Subject: AP1000 COL Standard Technical Report Submittal

APP-GW-GLR-074, Revision 0

Pipe Break Hazards Analysis

Technical Report Number 7

Figure 4-1

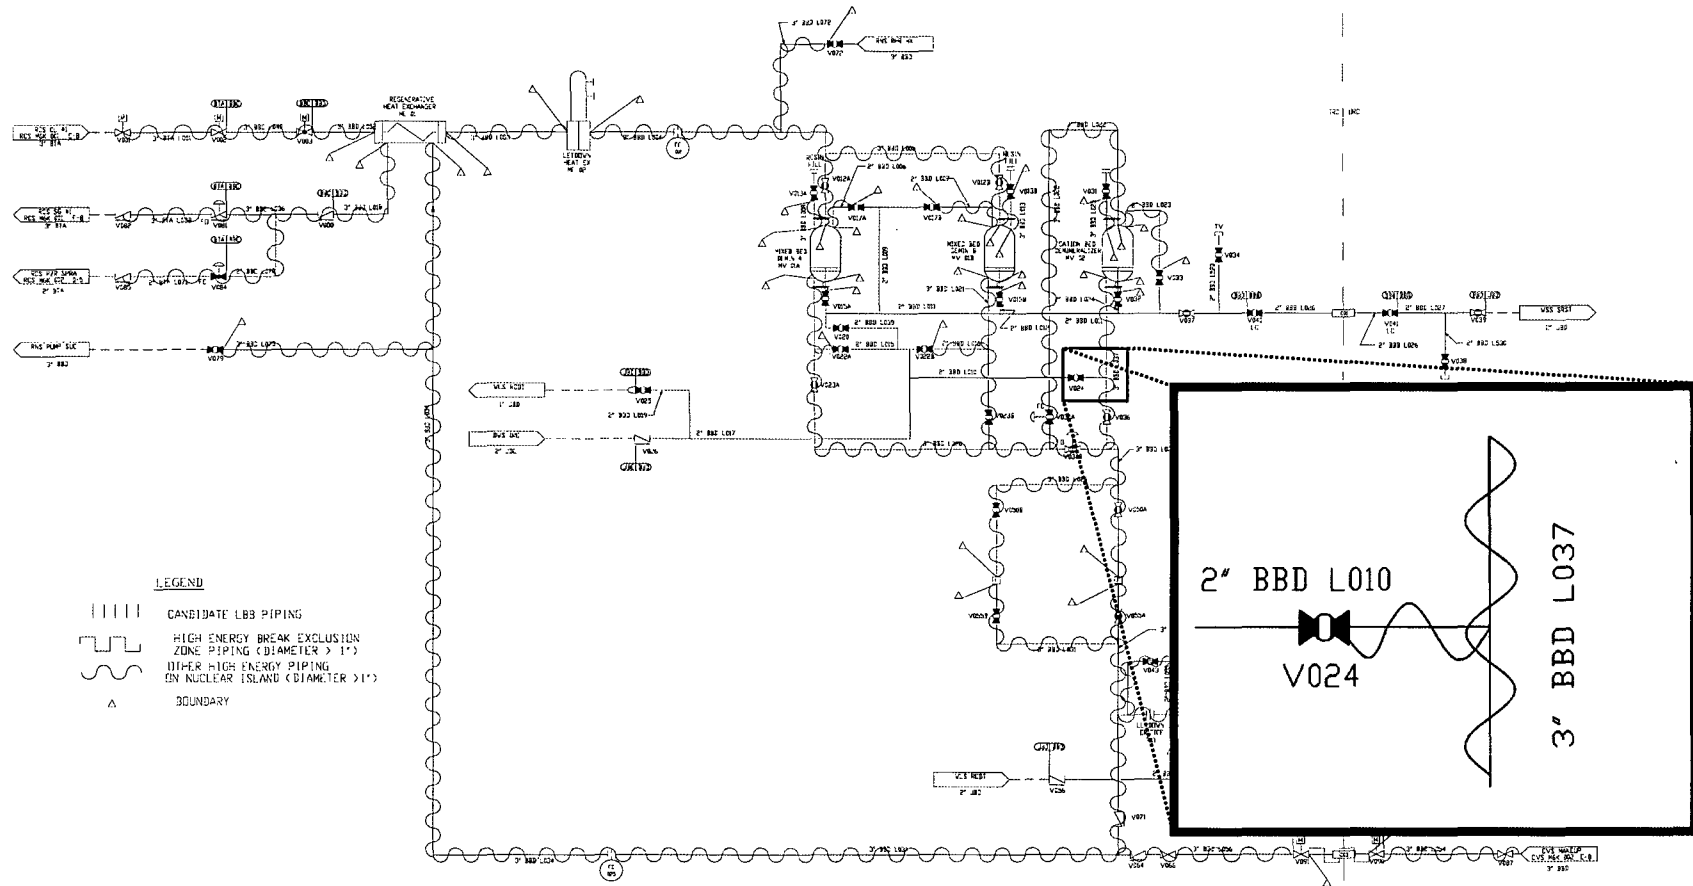
The High Energy Piping – Chemical and Volume Control System drawing in Appendix 3E of the DCD is revised to indicate that an omitted branch between the tee at line L037 and closed valve V024 is high energy. The change markup for DCD Figure 3E-5 (Sheet 1 of 2) is in Figure 4-1. The AP1000 Leak-Before-Break Evaluation of As-Designed Piping topical report (Reference 6), submitted July of 2006, contains markups of two additional drawings in Appendix 3E of the DCD. These DCD figures are High Energy Piping – Passive Core Cooling System (Figure 3E-4) and High Energy Piping – Reactor Coolant System (DCD Figure 3E-3).

**High Energy Piping – Chemical and Volume Control System  
(Revised, DCD Figure 3E-5 – Sheet 1 of 2)**
